ON-SITE SEWAGE DISPOSAL SYSTEM HOWARD COUNTY HEALTH DEPARTMENT BUREAU OF ENVIRONMENTAL HEALTH

SUBDIVISION: Robert Williams Farm LOT NUMBER: tenant house

ADDRESS: 13000 Linden Church Road PROPERTY OWNER: William/Sherry Slade

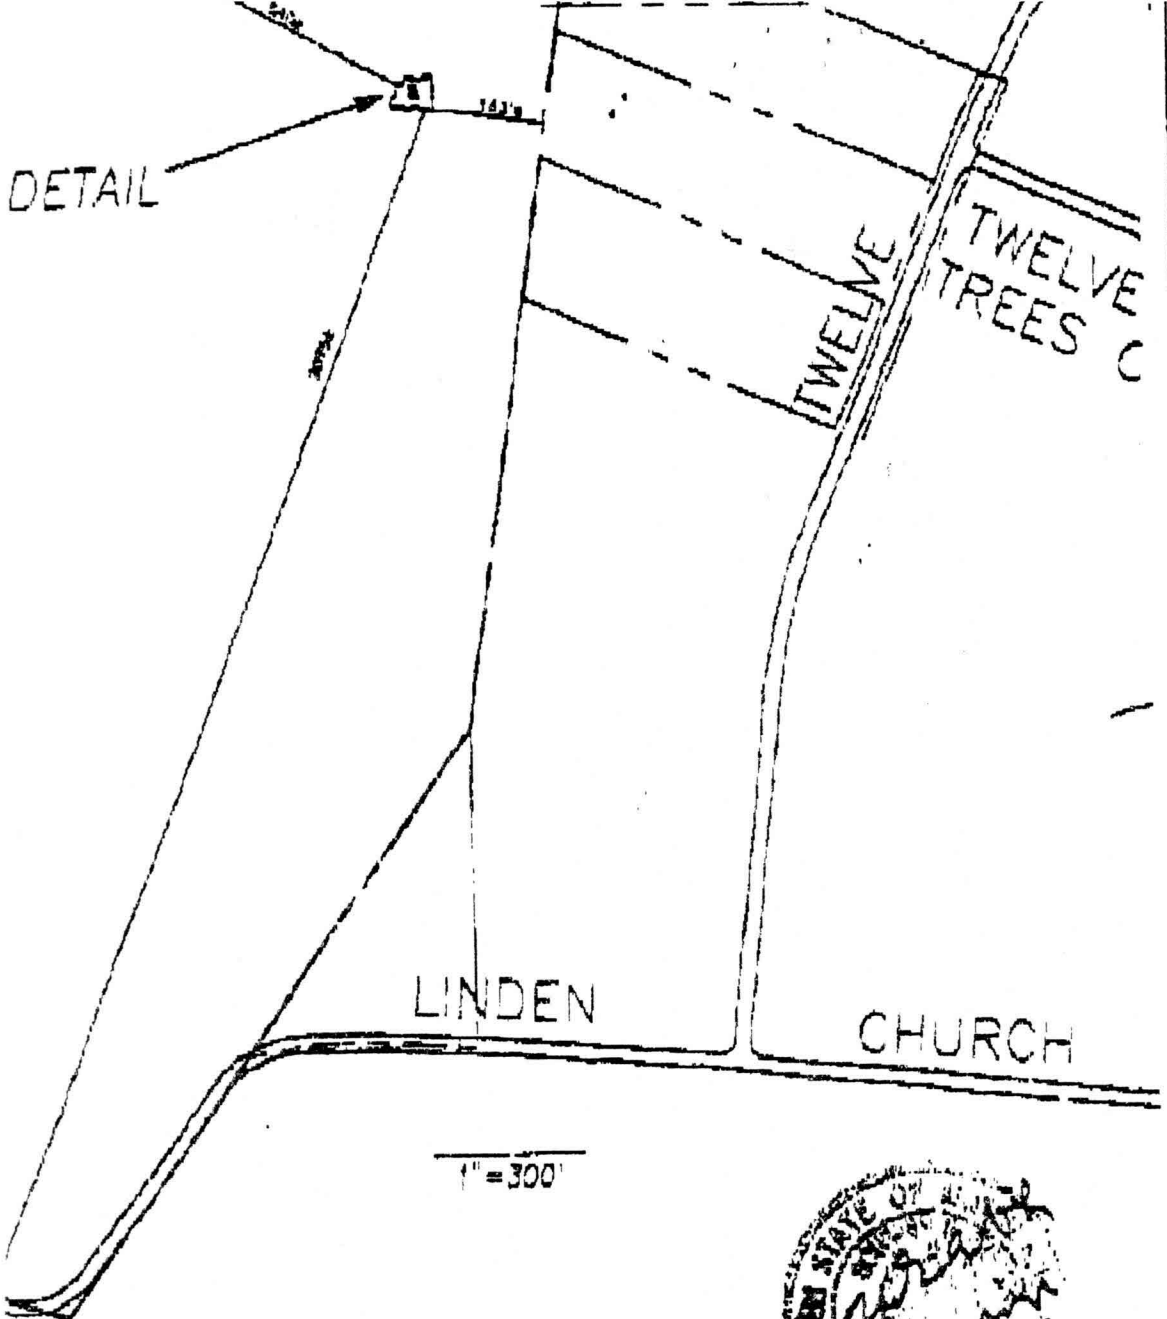
PRE-CONSTRUCTION INSPECTION: 8/30/01 - OK TO PROCEED PER APPROVED BP PLAN - (SR10)

INSPECTION COMMENTS: 9/5/01 INSP APPOINTMENT NOT COMPLETED VIA T/C
GAVE OK TO COVER MIDDLE OF ONE TRENCH, AND P/O HOUSE CONN (MP)
9/6/01 OK TO COVER - FINAL SIGNED. CALLED MARK TO VERIFY "NOTE" (KG)

DETAIL

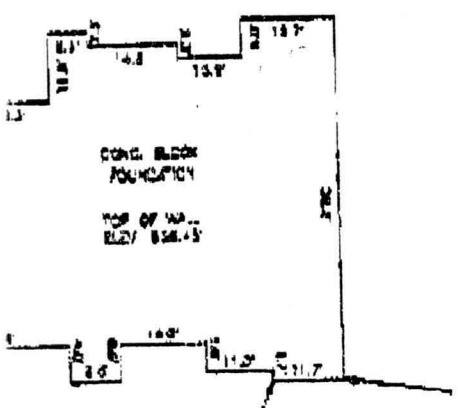
7/23/01
 Difficult to read, but house location appears consistent w/ approved BP site Plan *(D/C)*
